Air Conditioning Is Not Cold Enough (Replace Condenser) #02-01-38-004A - (Apr 27, 2005)

2002 Buick Rendezvous

2001-2002 Chevrolet Venture

2001-2002 Pontiac Aztek, Montana

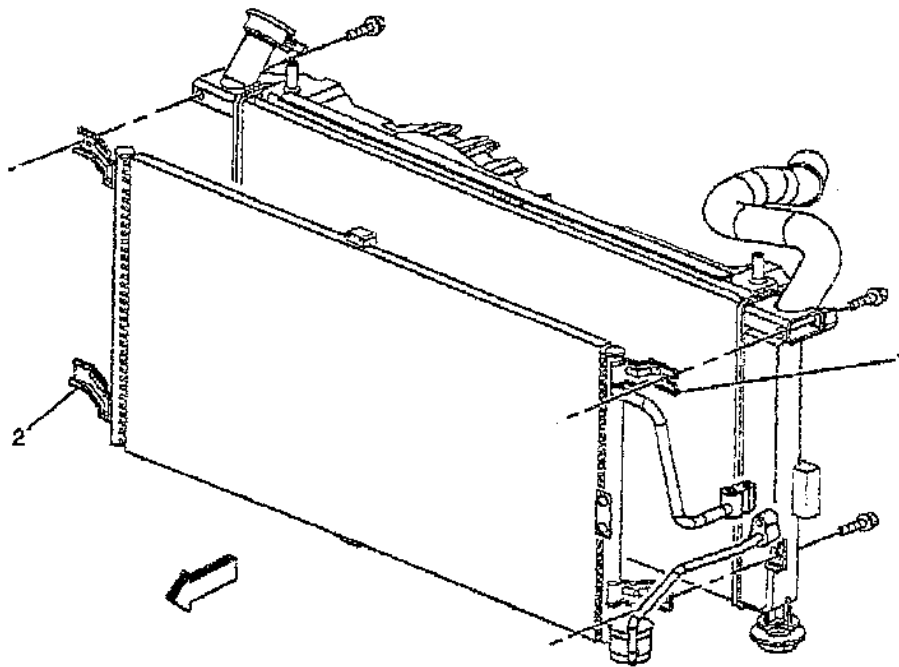
Technicians may find that the condenser is cracked and leaking at the lower right attachment bracket.

3. Refer to (1) and (2) in the illustration above to find the locations where the condenser to radiator mounting will be changed.
4. At (2), (lower right attachment bracket), the new condenser will not have a hole in the bracket. Discard the bolt and J-nut that was used at this location with the original condenser.
5. At (1), (upper left attachment bracket), install a new J-nut, P/N 10335492, on the slotted condenser attachment bracket. Reuse the bolt that was in this location with the original condenser.
6. Perform all the rest of the steps listed in the replacement procedure.

Replace the condenser with an updated design part. Use the following procedure to install a new condenser and modify the way the condenser is mounted to the radiator in the vehicle.

1. Remove the condenser using the steps given in the Condenser Replacement procedure in S1.
2. The new condenser will be installed using the steps in the Condenser Replacement procedure in S1, with the exception of two changes in the way the condenser is mounted to the radiator.
